TRANSMITTER

TY-W1268-1(A) 49.860MHz

Drawing No. T1243

TAIYO KOGYO CO., LTD

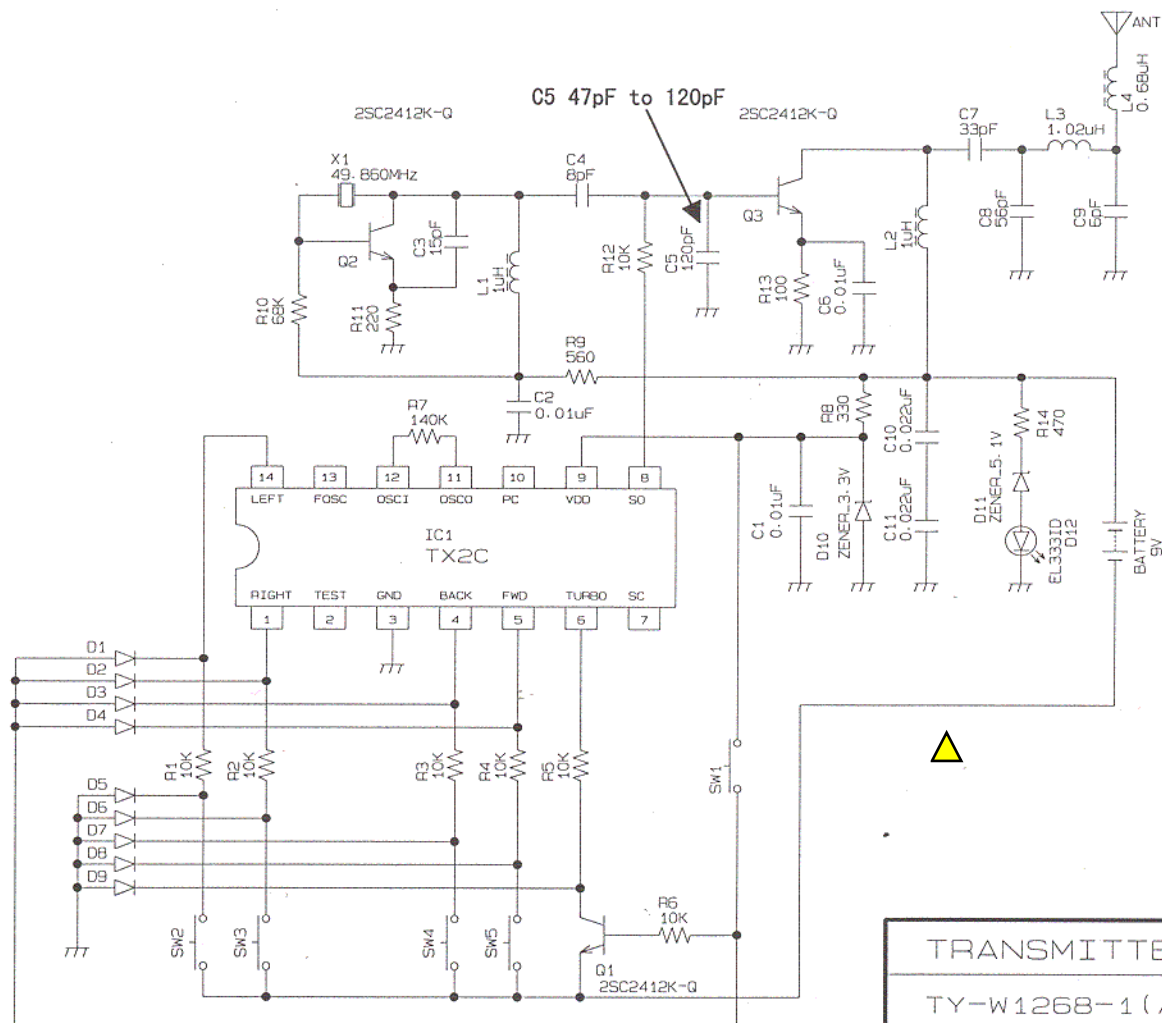
Condencer C5 47pF was changed to 120pF.
